PLAT COMMITTEE

Case Number:	2024-PLT-022
Property Address:	7725 Kentucky Ave. (<i>Approximate Address</i>)
Location:	Decatur Township, Council District # 21
Petitioner:	Lennar Homes of Indiana, LLC, by Jim Pence
Zoning:	D-4
Request:	Approval of a Subdivision Plat to be known as Noble Heights, Section 1, subdividing 23.11 acres into 66 lots.
Waiver Requested:	None
Current Land Use:	Undeveloped
Staff Reviewer:	Jeffrey York, Principal Planner I

STAFF RECOMMENDATION

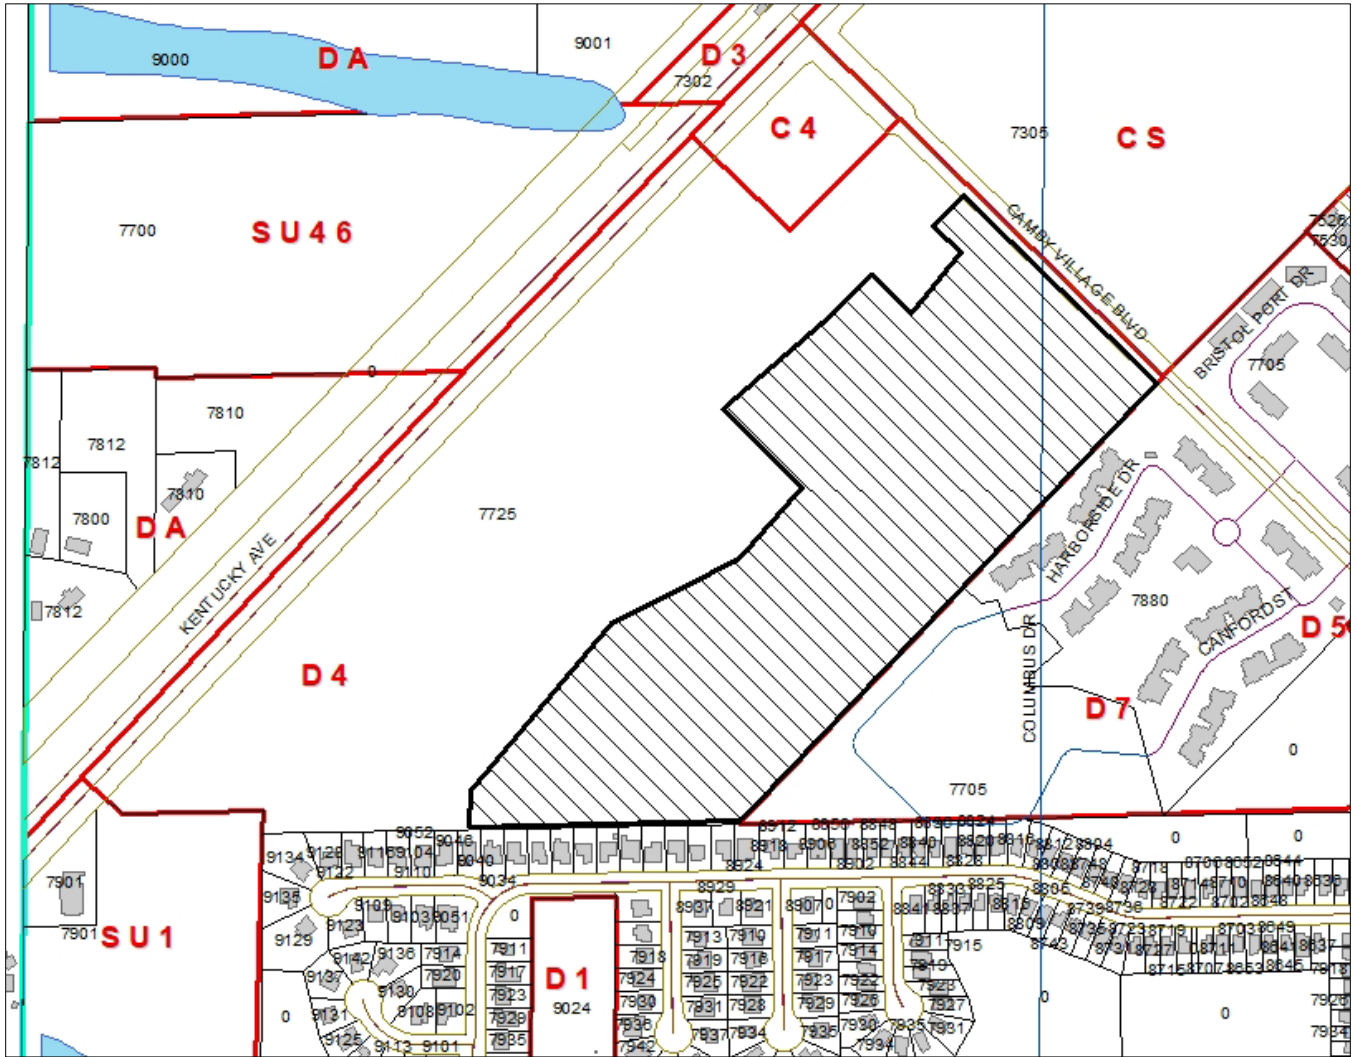
The subject site is zoned D-4. The plat would establish 66 total lots in the first section of the overall development. This plat includes Common Areas A, B, C, and D. Section 1 also includes a cul-de-sac.

Access would include two (2) connection points from proposed Camby Village Blvd. All lots would be accessible by internal thoroughfares with proper signage compliant with city standards.

6' wide sidewalks are to be installed along internal thoroughfares with a 5' wide common area path. This is compliant with the Zoning Ordinance and Subdivision Control Standards.

<p><i>741-303.D – Cul-de-sacs (Metro Context Area):</i></p> <ul style="list-style-type: none"> • In the Metro Context Area, cul-de-sac lengths shall not exceed 500 feet or serve more than 20 dwelling units. 	<p>Satisfied – 20 dwellings served on one cul-de-sac</p>
741-304-316 Additional Development Items		EVALUATION
	<p><i>741.304.A-C – Traffic Control Devices:</i></p> <ul style="list-style-type: none"> • <i>Street name signs, traffic control signs, bike route signs.</i> • <i>Traffic control devices for streets exceeding 900 feet in length.</i> • <i>Bicycle Facilities for subdivisions with a collector street serving more than 100 dwelling units.</i> 	<p>Satisfied</p>

Staff recommends that the Plat Committee **approve** and find that the plat, file-dated April 22, 2024, complies with the standards of the Subdivision regulations, subject to the following conditions:
